**1 Products affected**

Ground terminal assembled with a clamping plate.

<b>4795</b>					<b>0118.2305</b>	
creation date	created by	release date	released by	notification no.	revision	page
2015-09-02	bisanger	2015-09-30	bisanger	27929	-	1 of 2

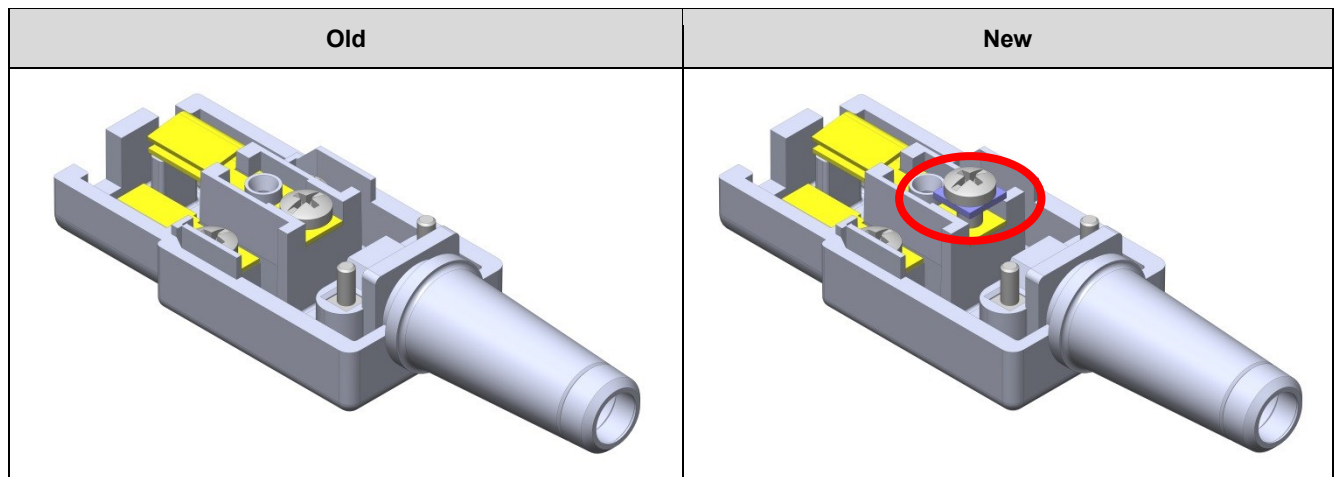
The terminal screw "Ground" is pre-assembled with a clamping plate, which will retain all individual wires below the screw head (blue part in picture below).

An uncareful wire insertion could lead to unsatisfactory screw connection. The clamping plate makes the handling easier and the screw connection more safe.

Form:	No	There are no form changes
Fit:	Yes	Screw terminal "Ground" assembled with a clamping plate
Function:	No	This is a non-functional change
Production Site:	No	There is no change of the production site
Product Label:	No	There is no change on the label
